# Access Compliance Report

## Public Rights-of-Way

### (Curb Ramps)

Intersection ID: 48262	Main Street: EAST_ARBORS_DR	Cross Street: CLAUDE_FREEMAN_DR	Location: SE
ADA ID: 73210191127D	Ramp Type: Perp	Initial Pass/Fail: Fail	Overall Compliance: No
Severity Score: 12.5			
Codes/Mitigation Info/Possible Solution		Field Measurements/Component Compliance

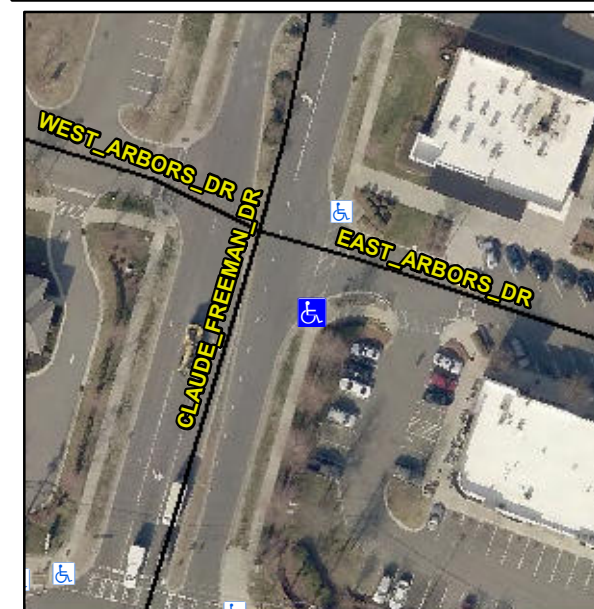
**Not Found, R304.5.3**

Compliance	Description	Data	Compliance	Description	Data
N/A	Ramp Length (in)	47.0	Yes	Ramp Slope (%)	5.3
Yes	Ramp Width (in)	55.5	No	Ramp XSlope (%)	6.6
N/A	Flare Type LT	N/A	N/A	Flare Type RT	N/A
N/A	Flare Slope LT (%)	N/A	N/A	Flare Slope RT (%)	N/A
N/A	Flare Traversable LT?	N/A	N/A	Flare Traversable RT?	N/A
N/A	Landing Length (in)	N/A	N/A	DWS Provided?	N/A
N/A	Landing Width (in)	N/A	N/A	DWS Contrast?	N/A
N/A	Landing Slope (%)	N/A	N/A	DWS Length (in)	N/A
N/A	Landing X Slope (%)	N/A	N/A	DWS Full Width?	N/A
N/A	Landing Curb? (Y/N)	N/A	N/A	DWS Offset (in)	N/A
N/A	Shared Landing?	N/A			
N/A	Gutter Ponding?	N/A	N/A	Gutter Slope (%)	N/A
N/A	Gutter Lip Ht (in)	N/A	N/A	Gutter X Slope (%)	N/A
N/A	Painted X Walk1?	Yes	N/A	Painted X Walk2?	N/A
	X Walk 1 Direction	To NE		X Walk 2 Direction	N/A
N/A	X Walk 1 Width (in)	87.0	N/A	X Walk 2 Width (in)	N/A
	X Walk 1 Slope (%)	6.0		X Walk 2 Slope (%)	N/A
	X Walk 1 X Slope (%)	2.0		X Walk 2 X Slope (%)	N/A

**Remove & Replace Entire Ramp.**
